Groundwater Transfer Review Summary Form

Transfer/PA # T- 14887

Ground Water Review Form:

Application: T-14887 Applicant Name: Arlene M Lucas Family Trust/Greg VanDamme

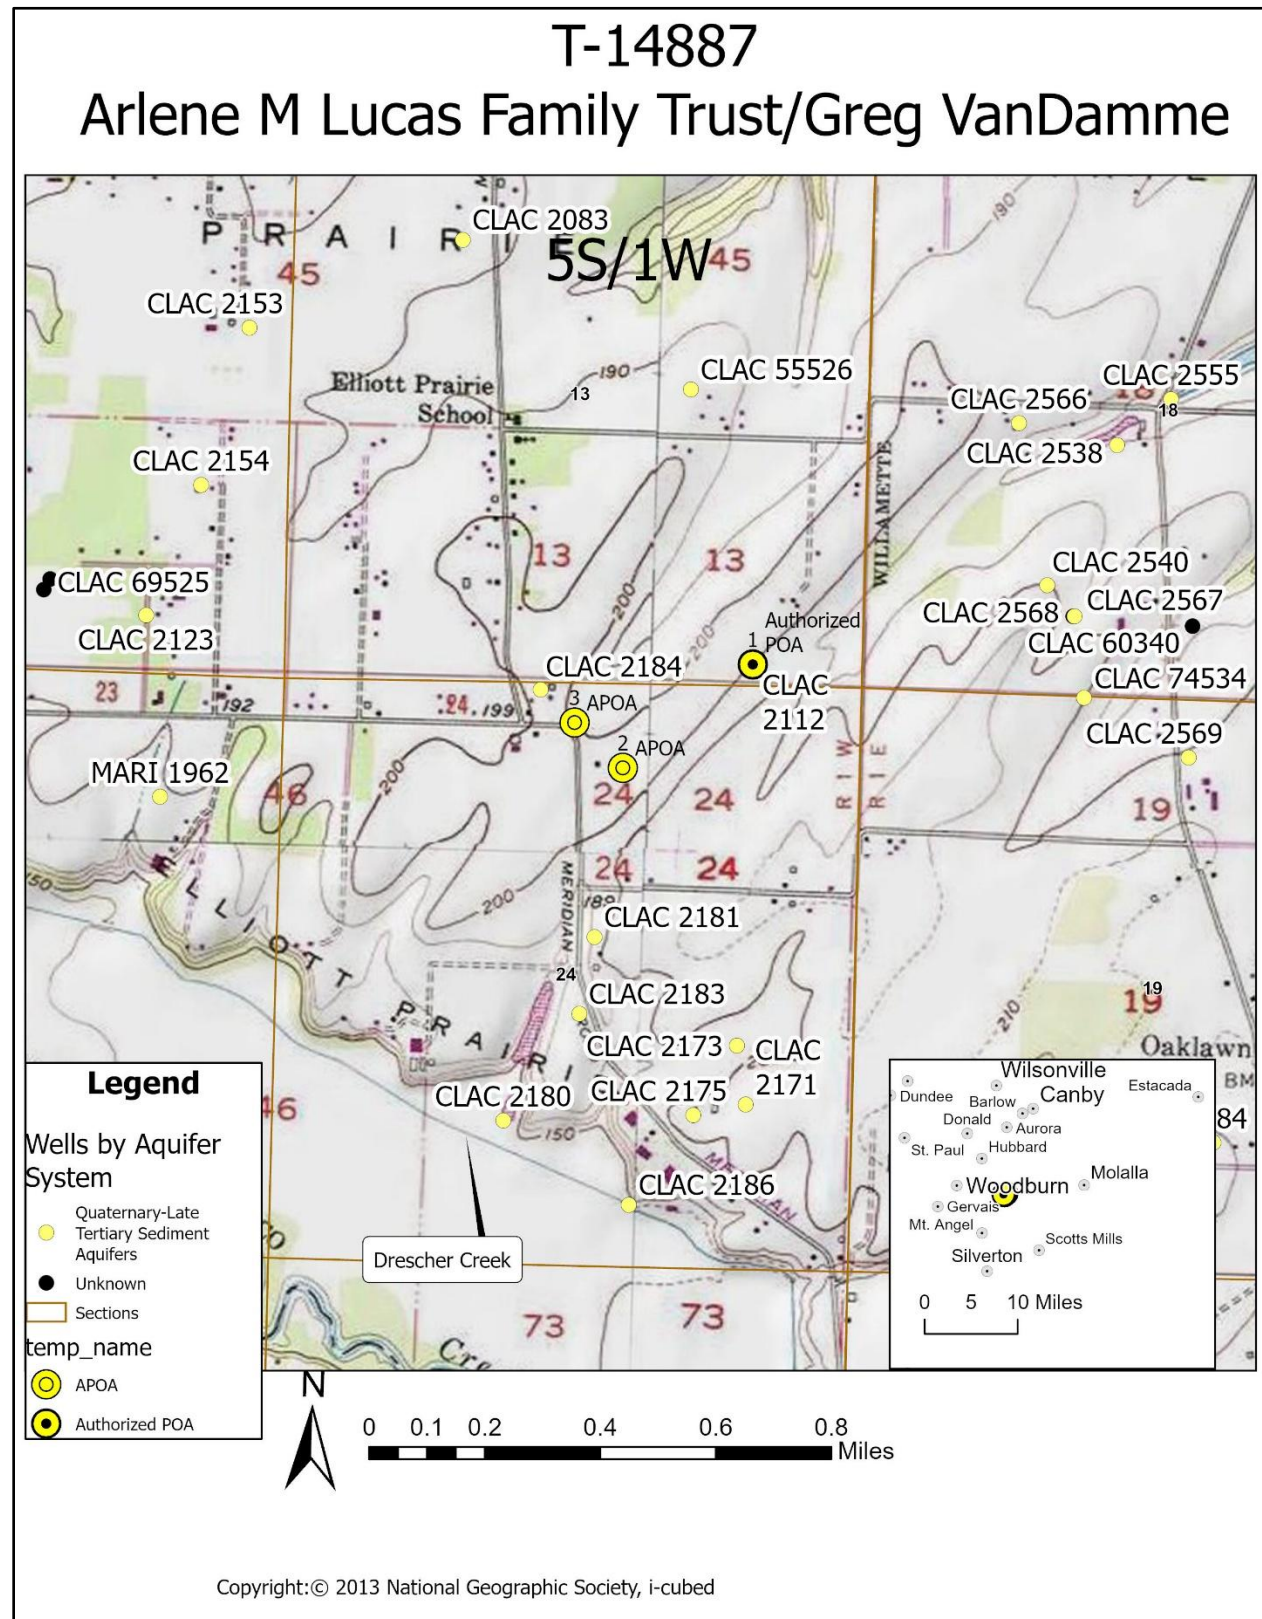
☒ Yes ☐ No Comments: Both APOAs (PROP 863/POA-2 and PROP 864/POA-3) are closer to Drescher Creek than the authorized POA (CLAC 2112). The reduced intervening distance is anticipated to result in an increase in interference with Drescher Creek.

Provide context for minimal/significant impact: The distance between the authorized POA (CLAC 2112) to Drescher Creek is approximately 5,000 ft and the distance between APOA 2/PROP 863 is 3,640 ft. Given the low transmissivity and low storativity values anticipated for this aquifer and the relatively small reduction in distance, the change in degree of interference with Drescher Creek is anticipated to be minimal.

Map

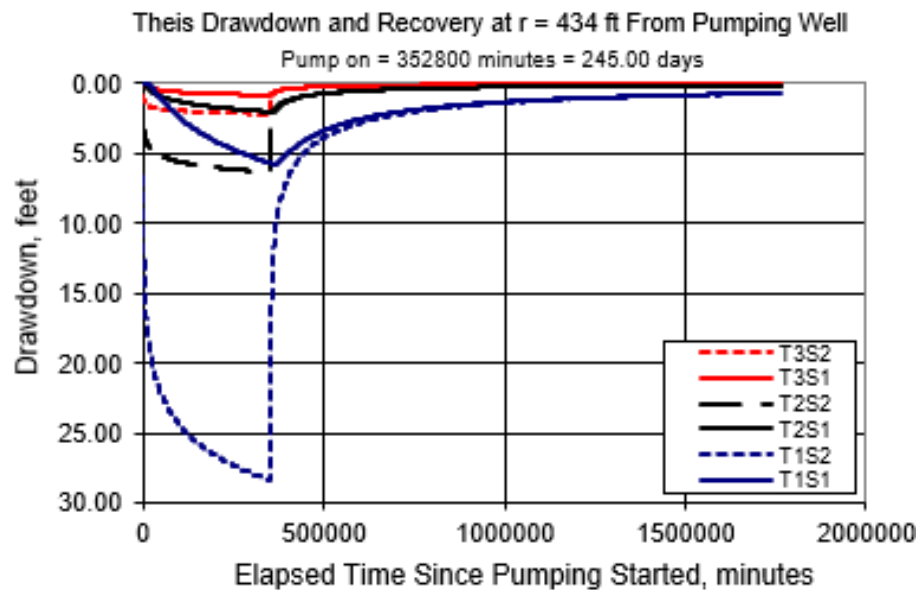
☒ Yes ☐ No Comments: APOA 3/PROP 864 is closer to CLAC 2184, which is a POA authorized under Claim GR-3627. The reduced intervening distance is anticipated to result in an increase in interference with CLAC 2184.

☐ Yes ☐ No If yes, explain: The Theis (1935) solution for drawdown was used to assess the potential for injury to CLAC 2184 from the proposed changes (see attached Theis Interference Analysis). Results indicate the proposed change is unlikely to result in CLAC 2184 not receiving the water to which it is legally entitled
